TRANS/WP.15/174Add.1

**Working Party on the Transport
of Dangerous Goods**

**DRAFT AMENDMENTS TO ANNEXES A AND B OF ADR ADOPTED
PROVISIONALLY (FOR ENTRY INTO FORCE ON 1 JANUARY 2005) BY THE
WORKING PARTY ON ITS SEVENTY-FOURTH SESSION (19-23 MAY 2003)**

FIGURES

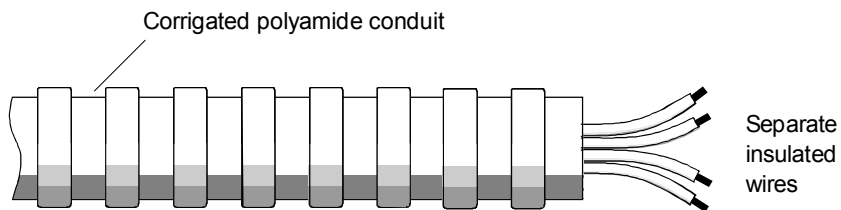
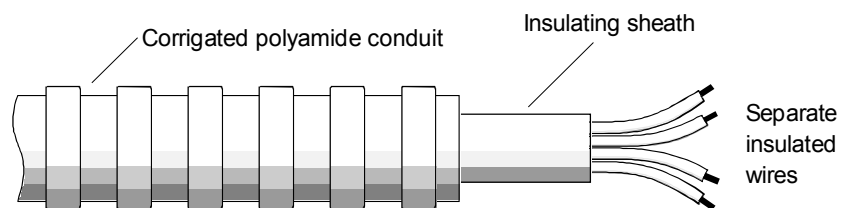
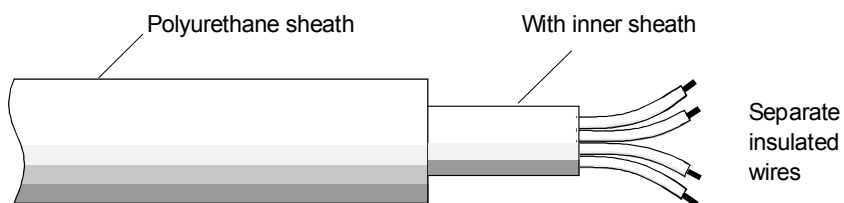
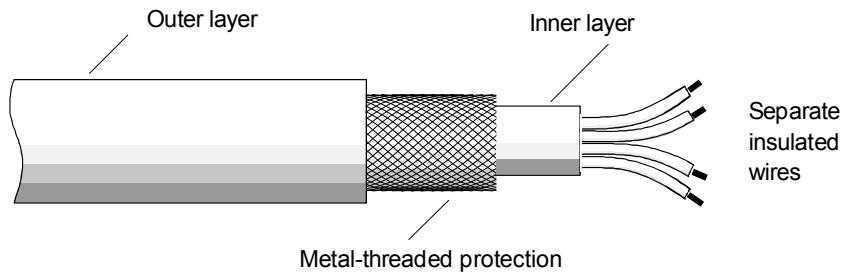
9.2.2.6.1 *Wiring*

The wiring located to the rear of the driver's cab shall be protected against impact, abrasion and chafing during normal vehicle operation. Examples of appropriate protection are given in figures 1, 2, 3 and 4 below. However, the sensor cables of anti-lock braking devices do not need additional protection.
